Planning Commission Regular Meeting

Tuesday, May 19, 2026, 6:30 PM
106 Center Street

To: Planning Commission

Excelsior Good Neighbor Guidelines PLAN Review

SHEET DESCRIPTION	COPYRIGHT
EXTERIOR ELEVATIONS	©2025
	STEVE'S DRAFTING & HOME DESIGN
	PLAN NUMBER
	G202511
	SHEET
	2
	OF
	9

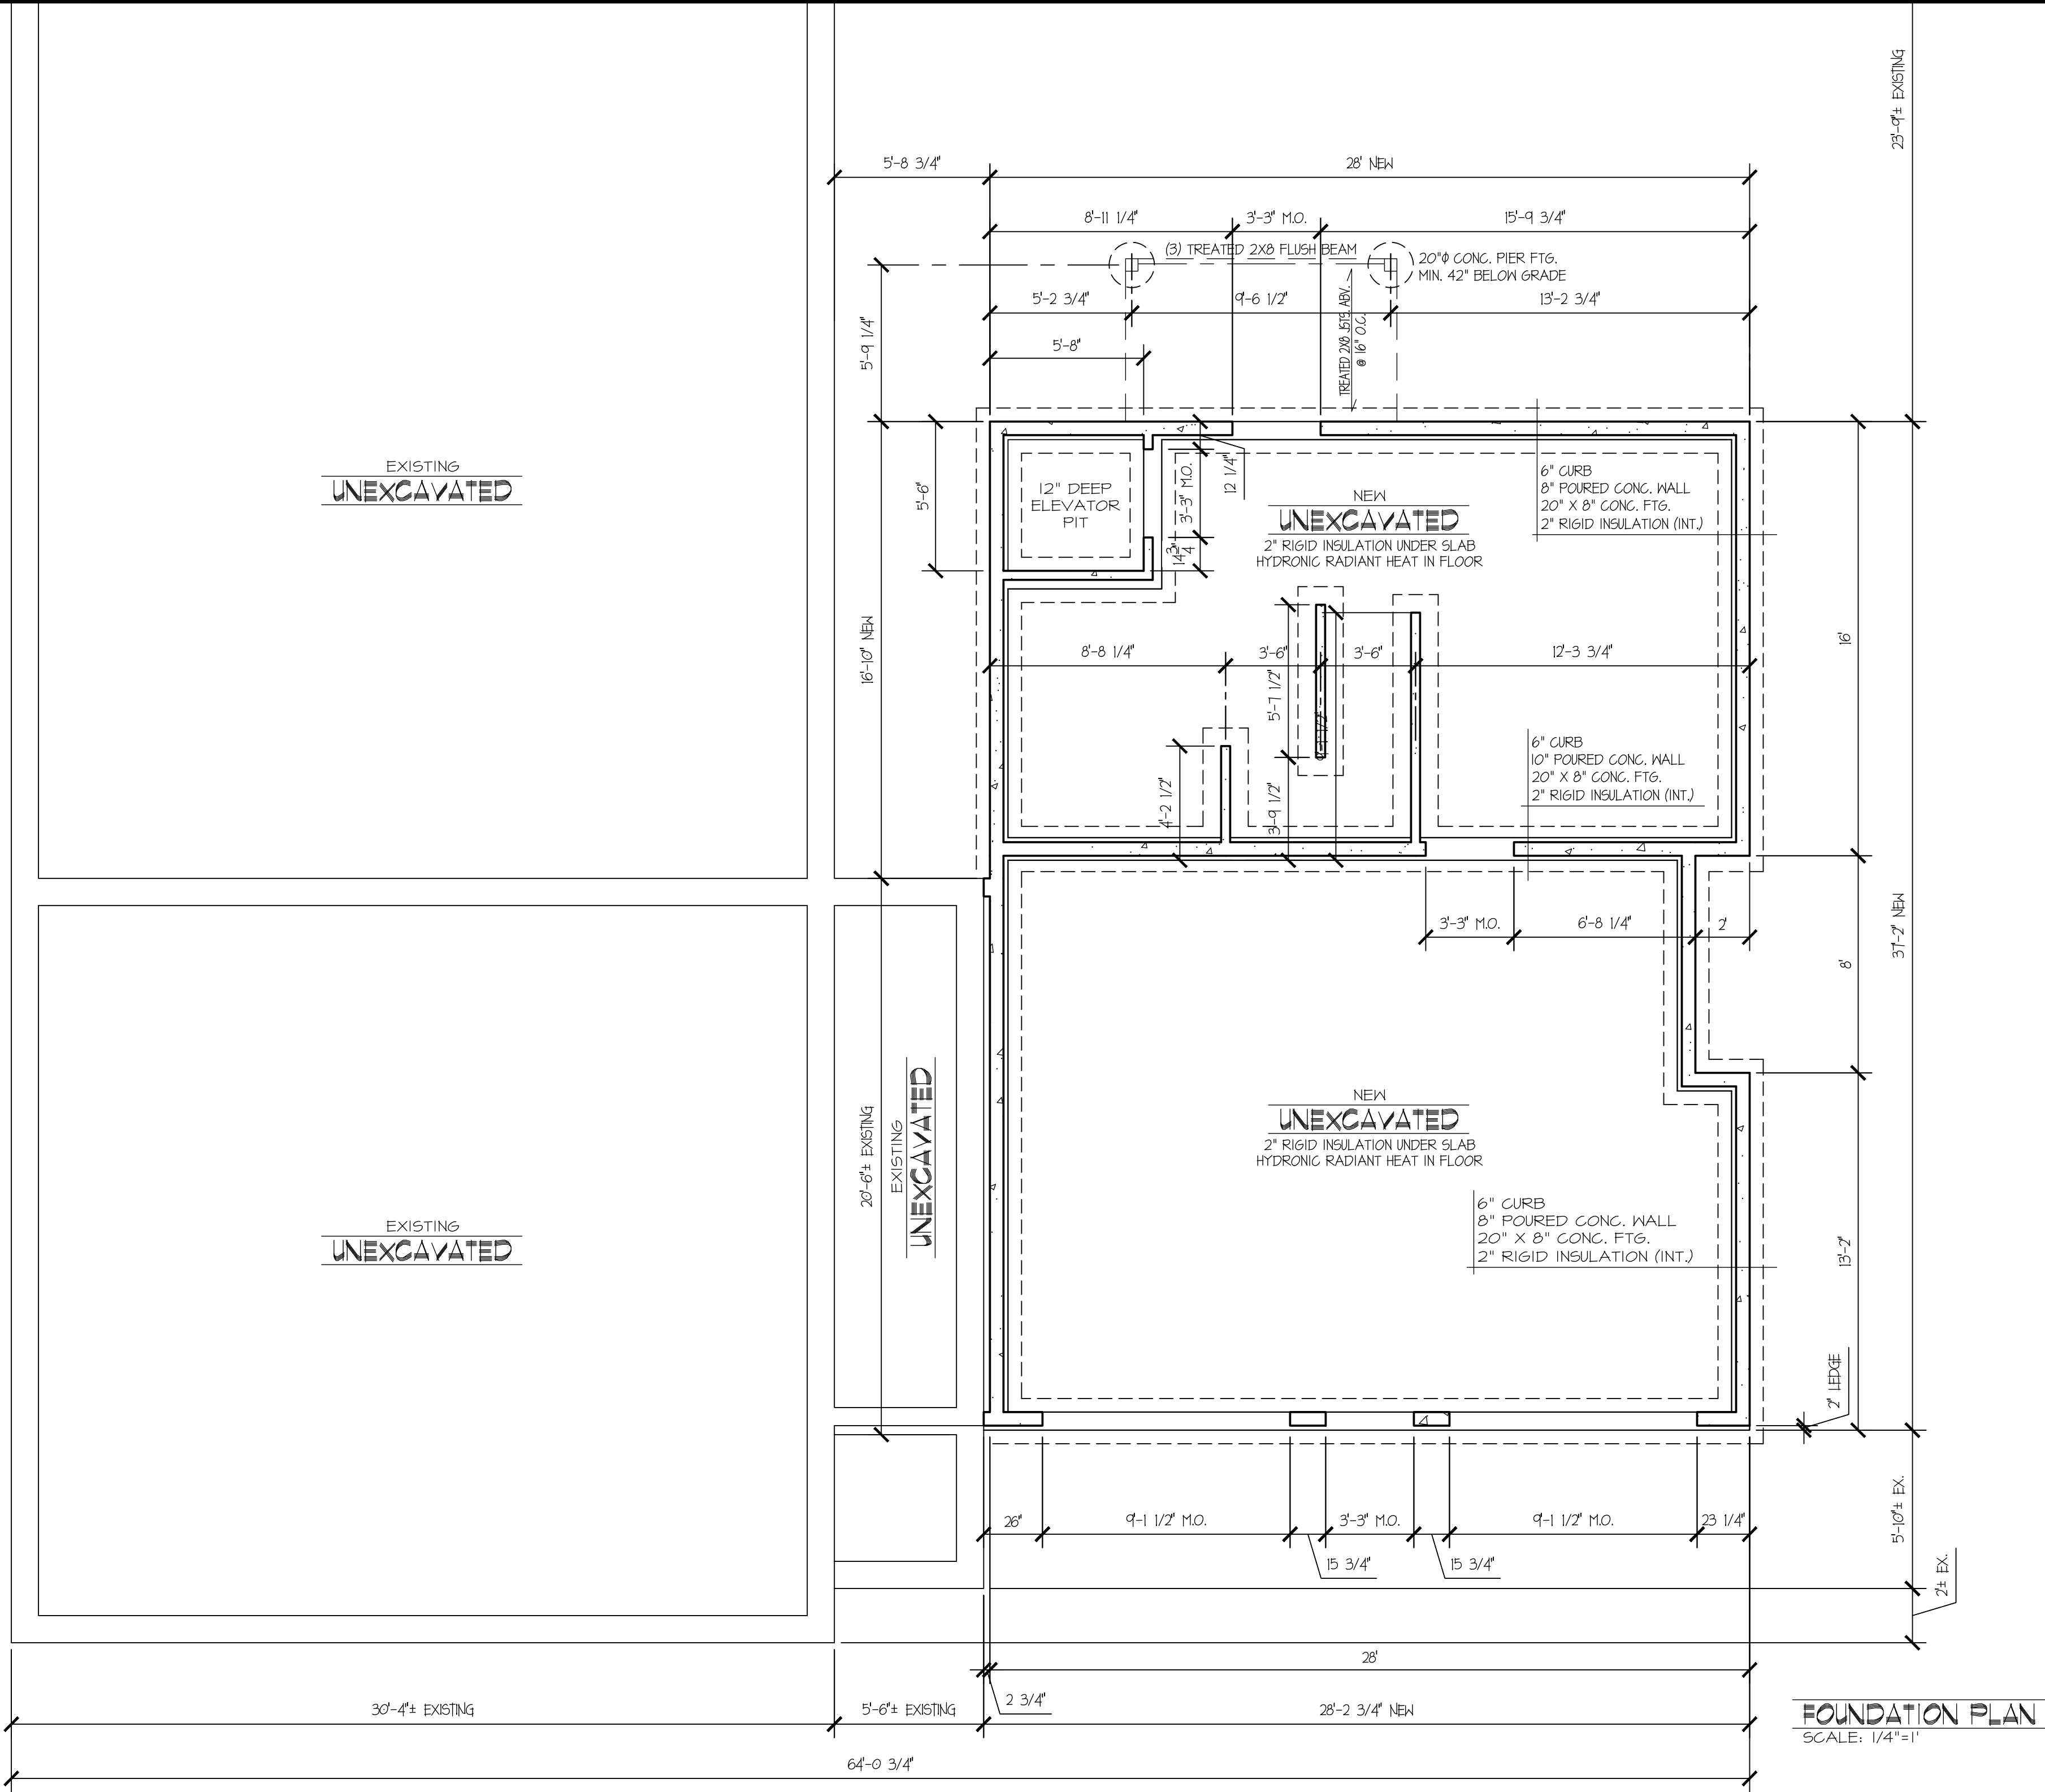
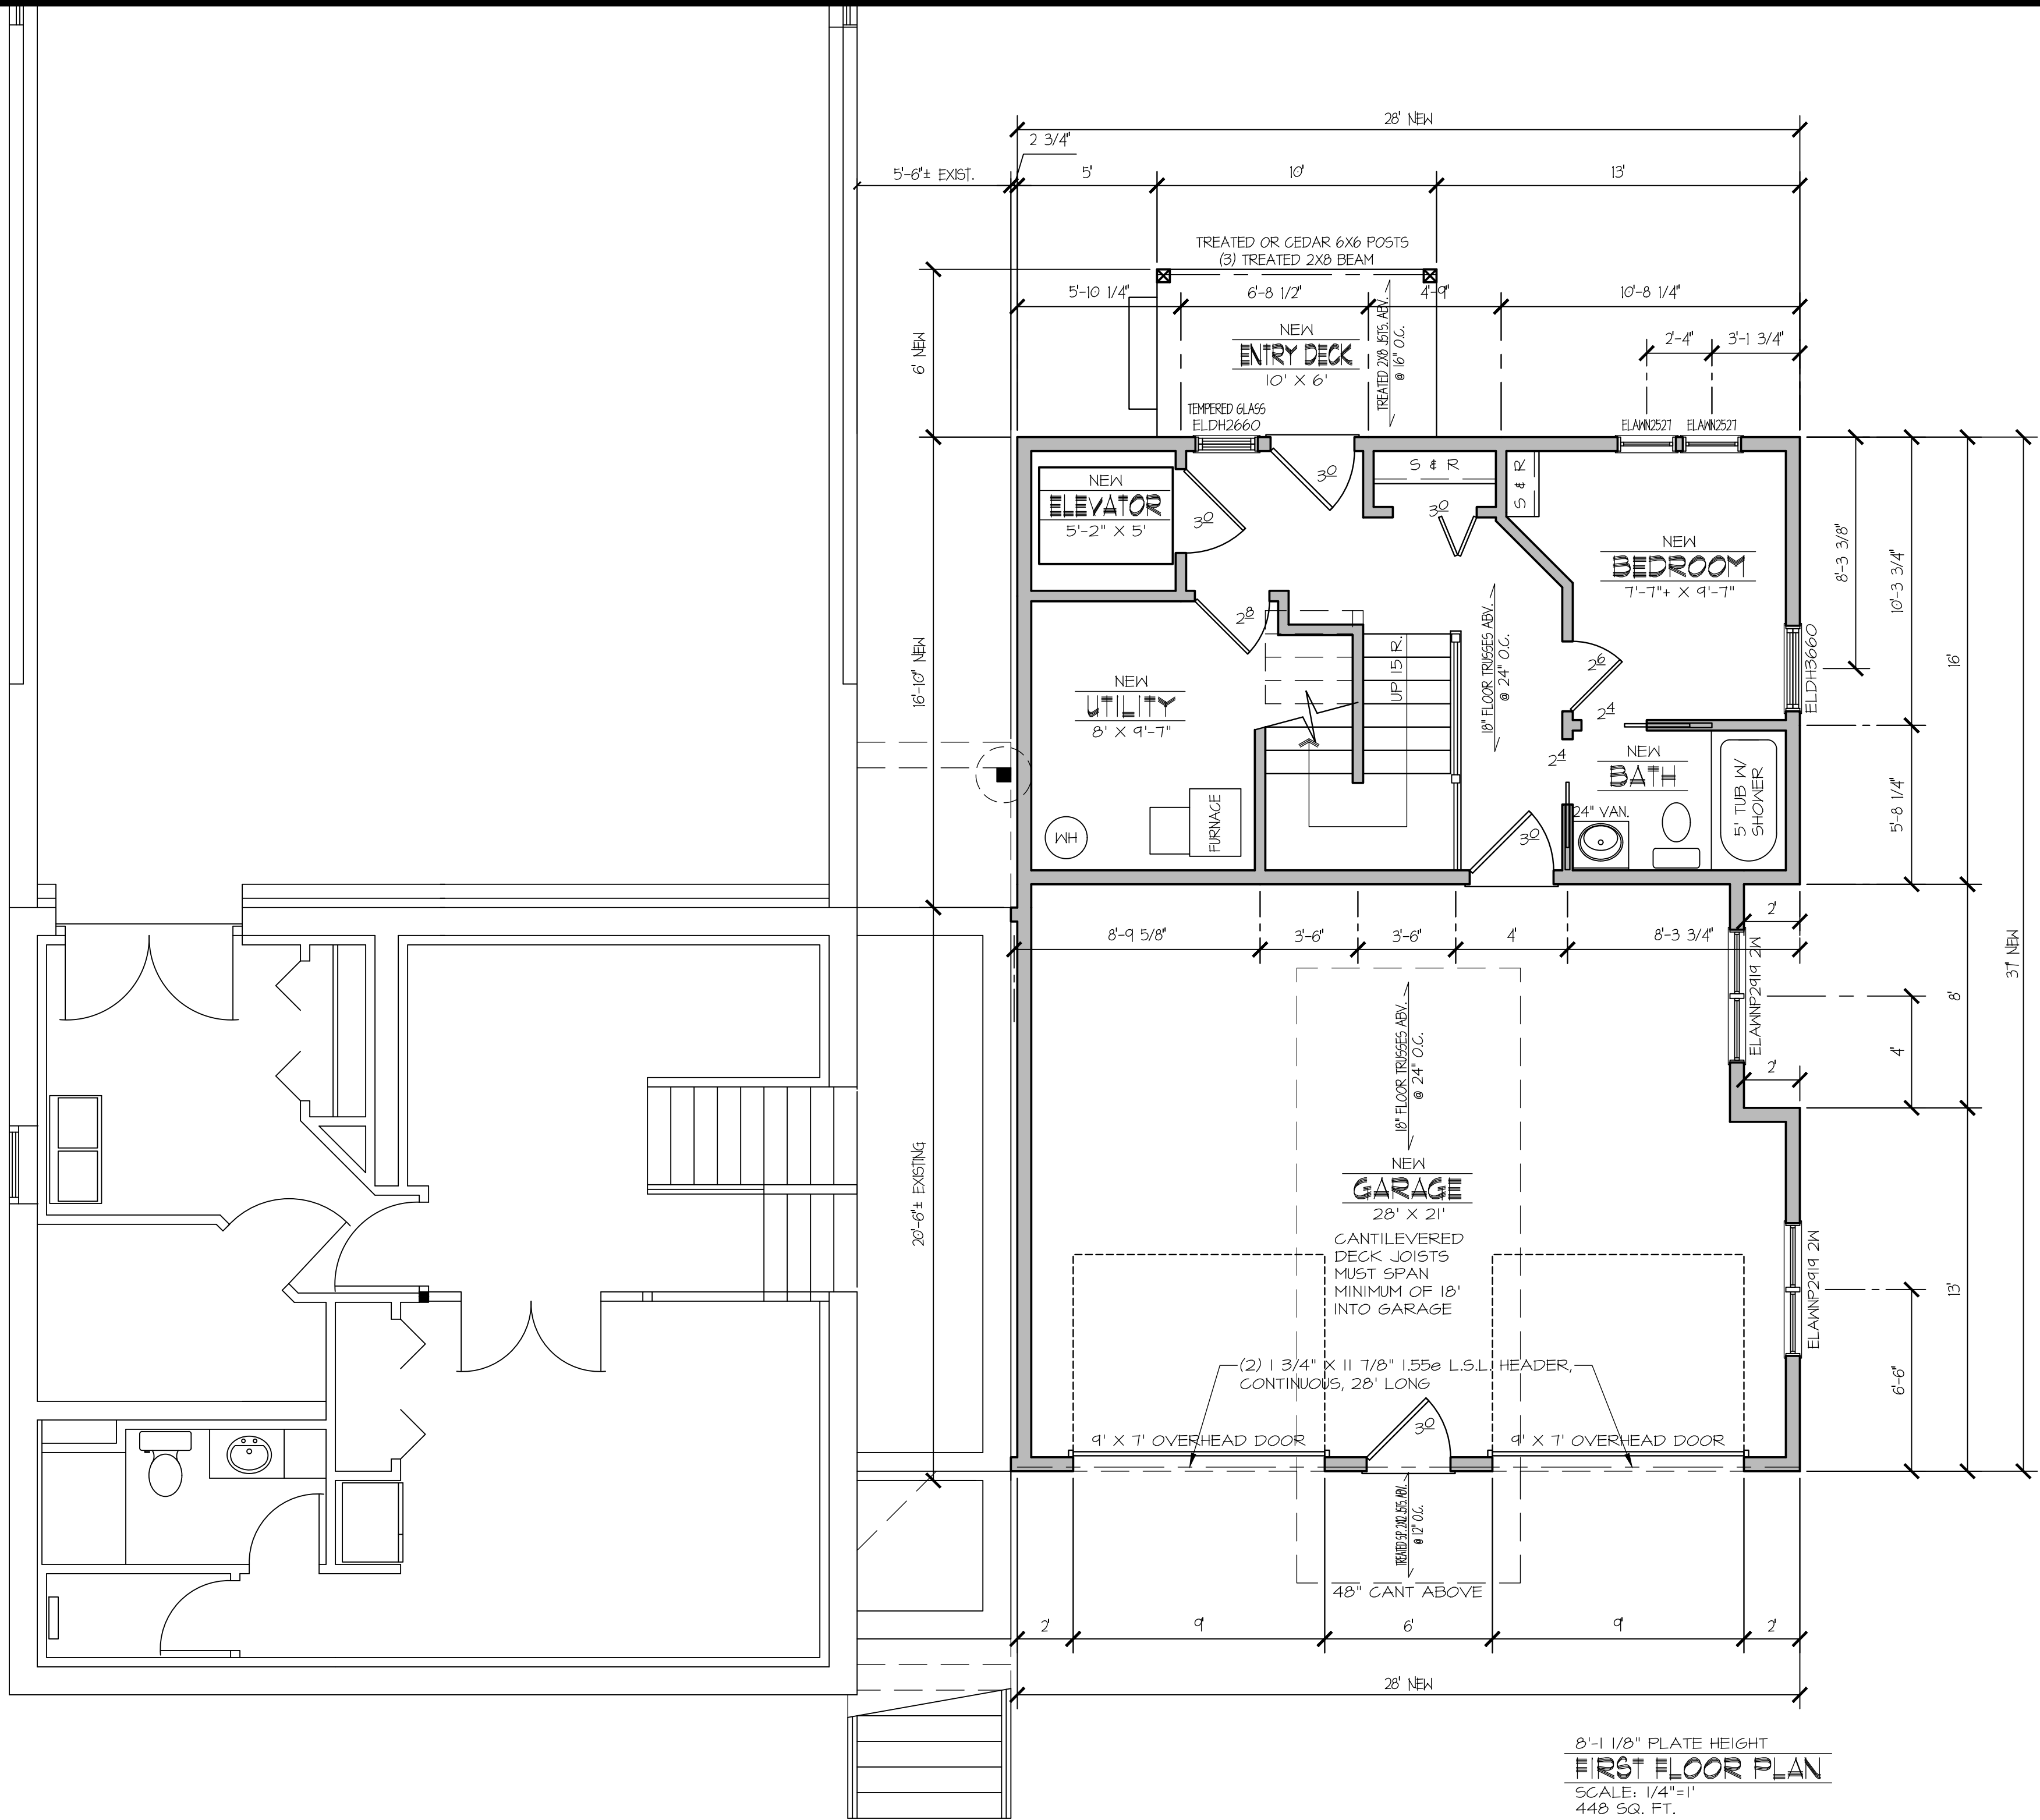
The proposed addition has minimal architectural detail and windows on the northeast and southeast elevations that demonstrate no symmetry.

CERTIFICATE OF SURVEY - PROPOSED

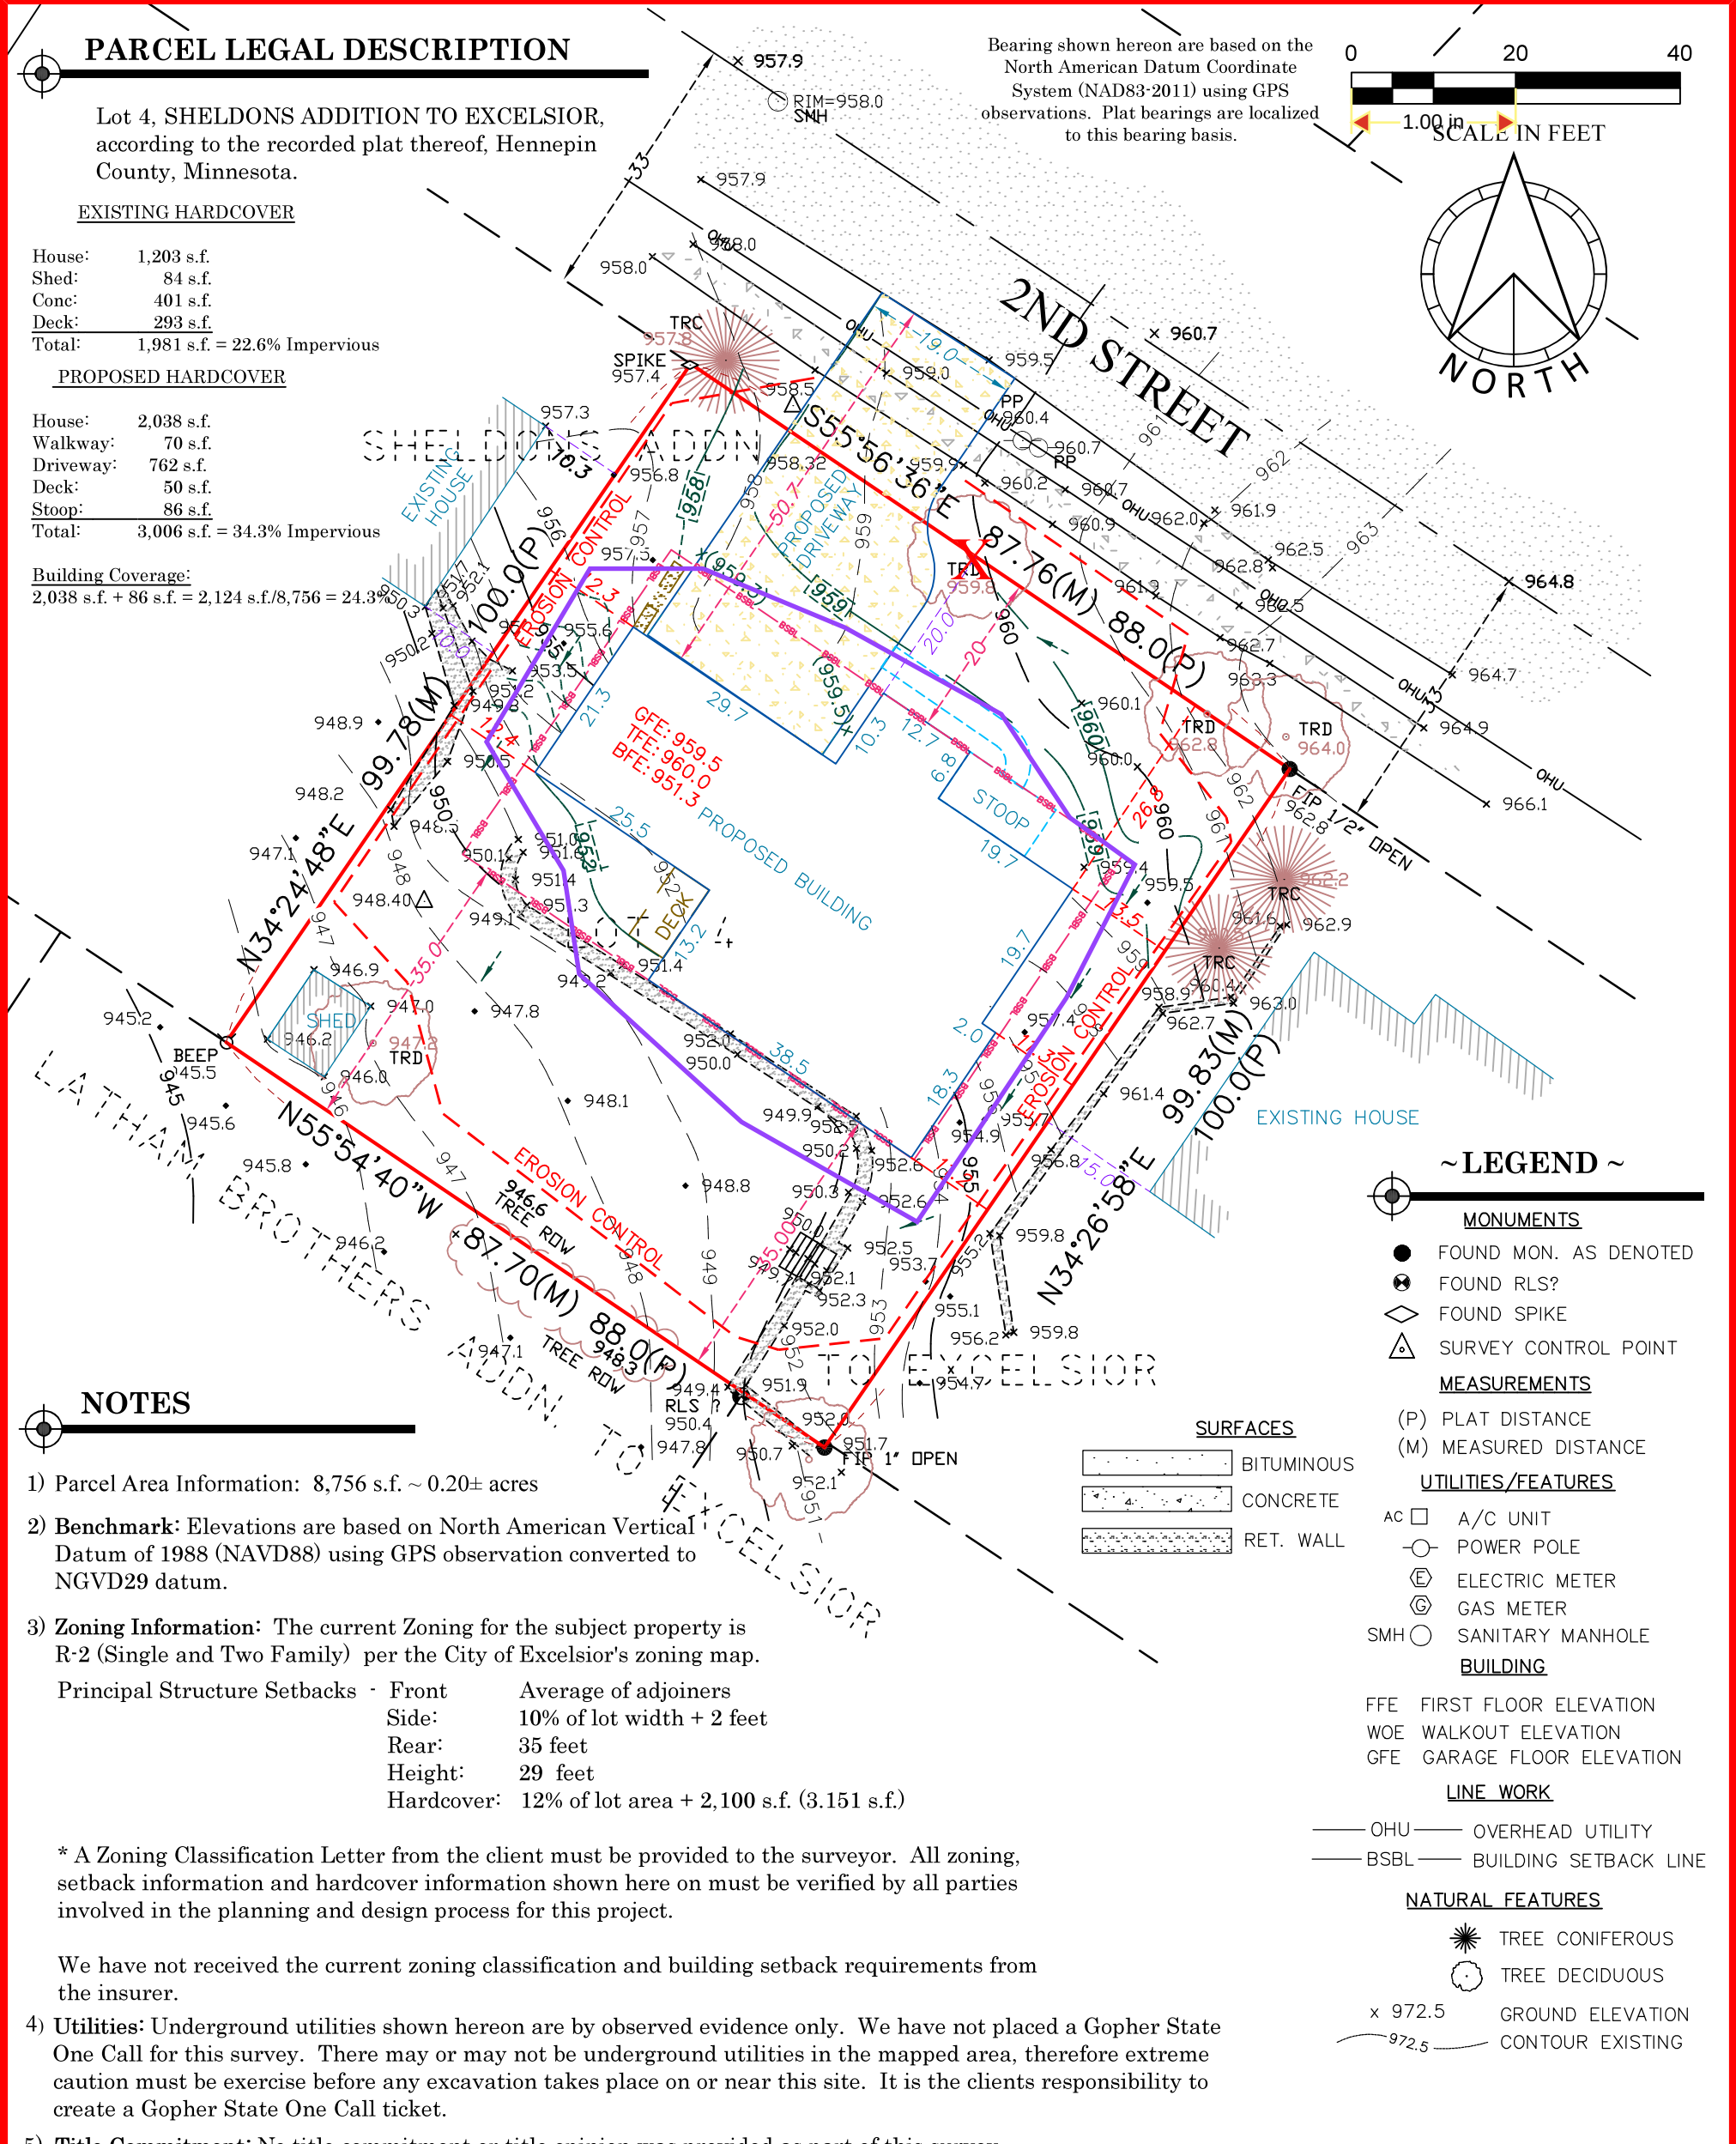
On the site plans, an existing +/- 2-0 high rear yard retaining wall is indicated about 18-0 from the rear wall of the existing house. The new design site plan shows the rear face of the house directly up against this retaining wall, with the wall intact, or rebuilt. A different retaining wall appears in plans, elevations and renderings. Applicant should explain & clarify the proposed retaining wall at the rear yard.
